May Design Vision Exhibition – Public Comments

Buffalo and Erie County Public Library Downtown – 54 comment cards

Design Vision for Ralph C. Wilson, Jr. Centennial P

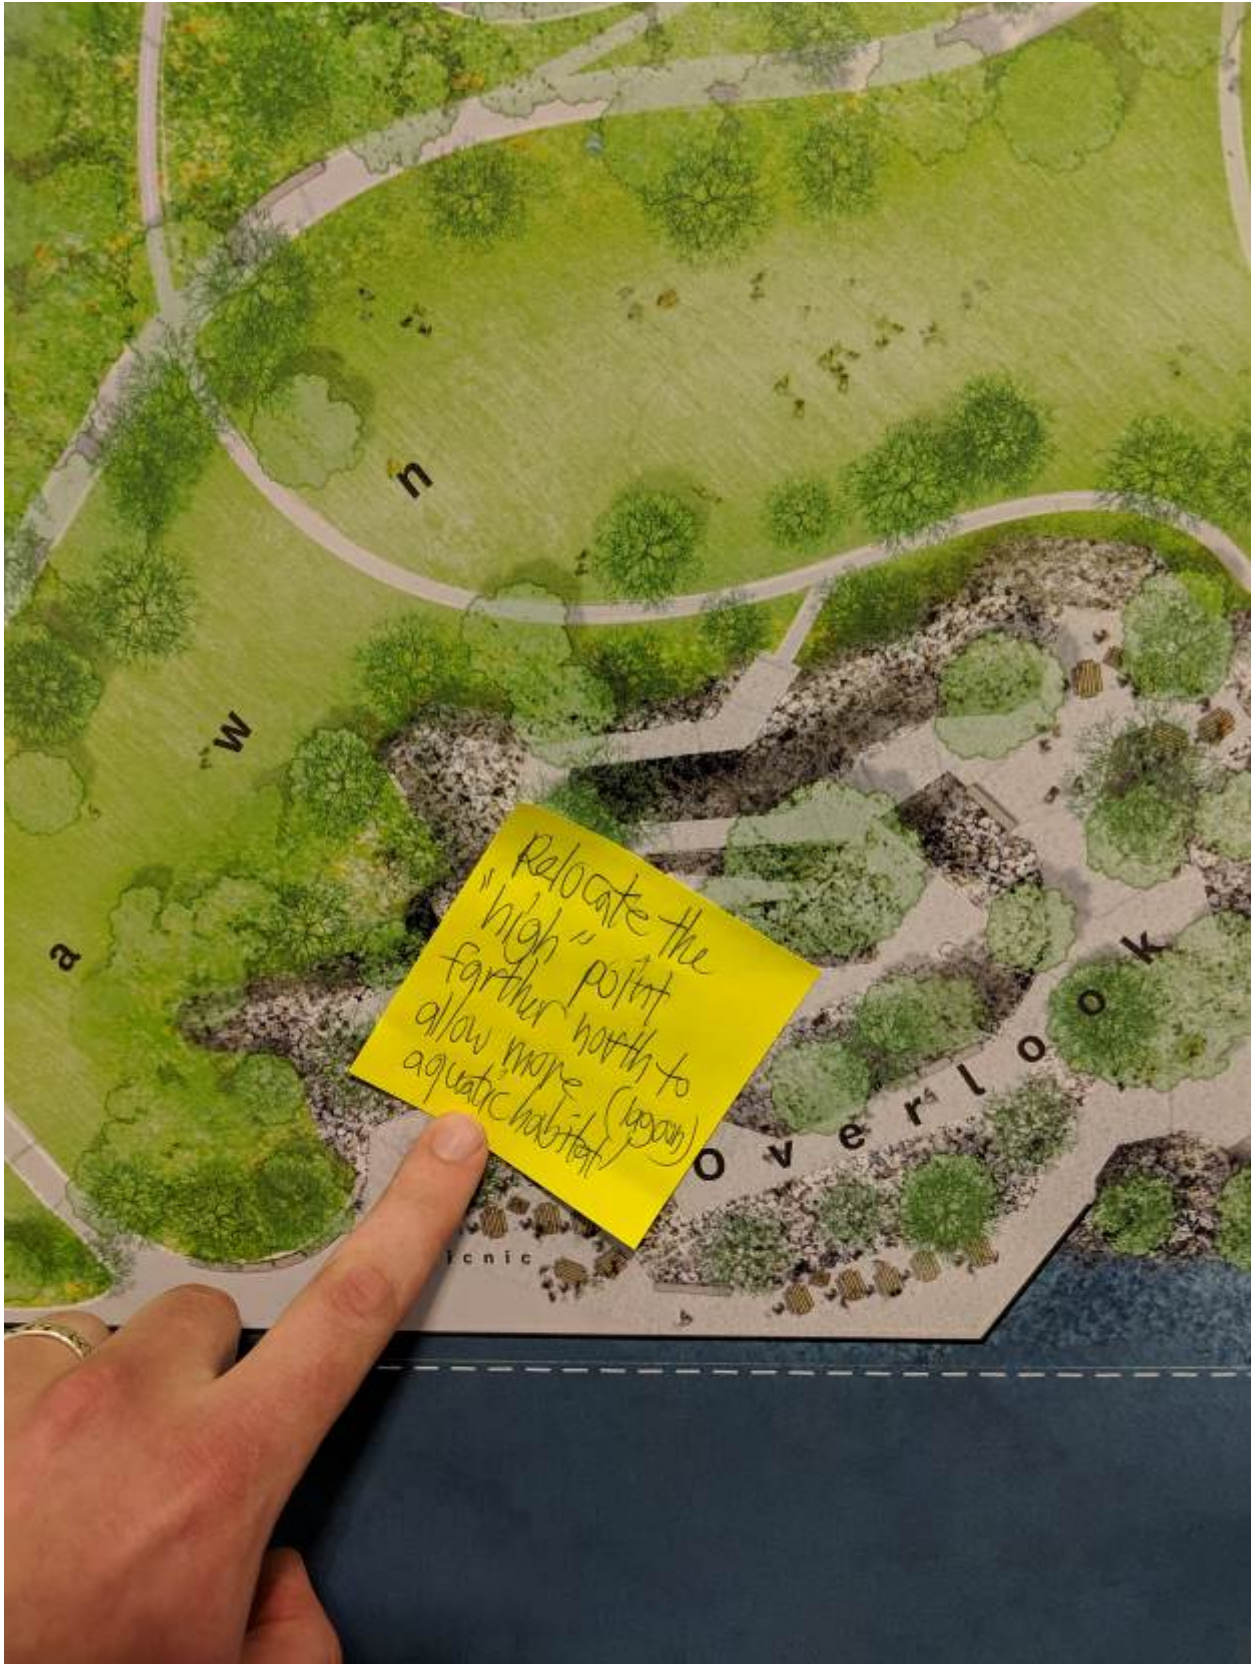
I have
seen draft
work all the
ways to help

Relocate the
"high" point
farther north to
allow more (open)
aquatic habitat

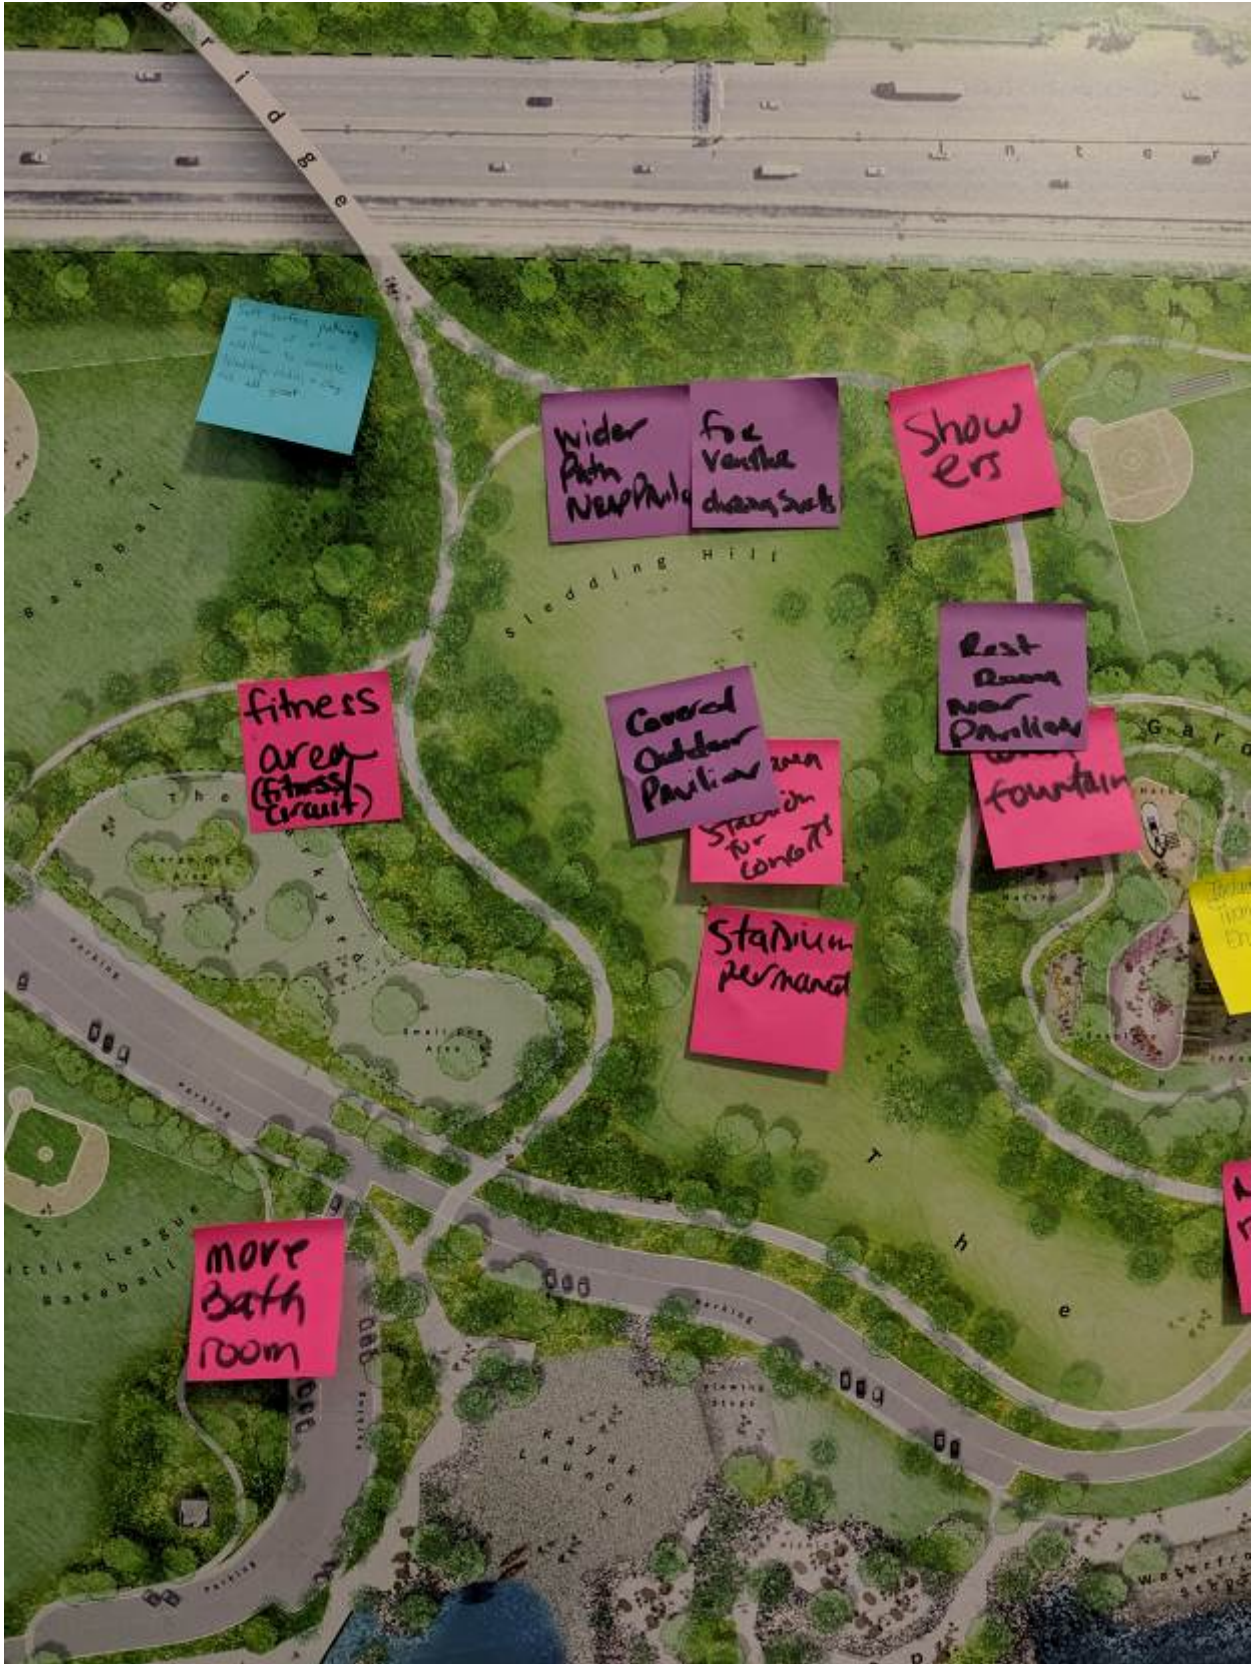
Overlook

picnic

with parking
area for
additional
parking
near
the
entrance

Wider
Path
Near
Path

for
Vending
Machine

Showers

fitness
area
(Fitness
Circuit)

Covered
Outdoor
Pavilion
area

Station
for
Concert

Stadium
permanent

Rest
Room
near
Pavilion

fountain

move
bath
room

Too many Disinfect

Pavilion or outdoor amphitheater

Indoor Pavilion to hold 700-3000

Handwritten note on yellow sticky paper: "Incorporate 'Law of Planning Station'?"

Emergency
water vehicle
access
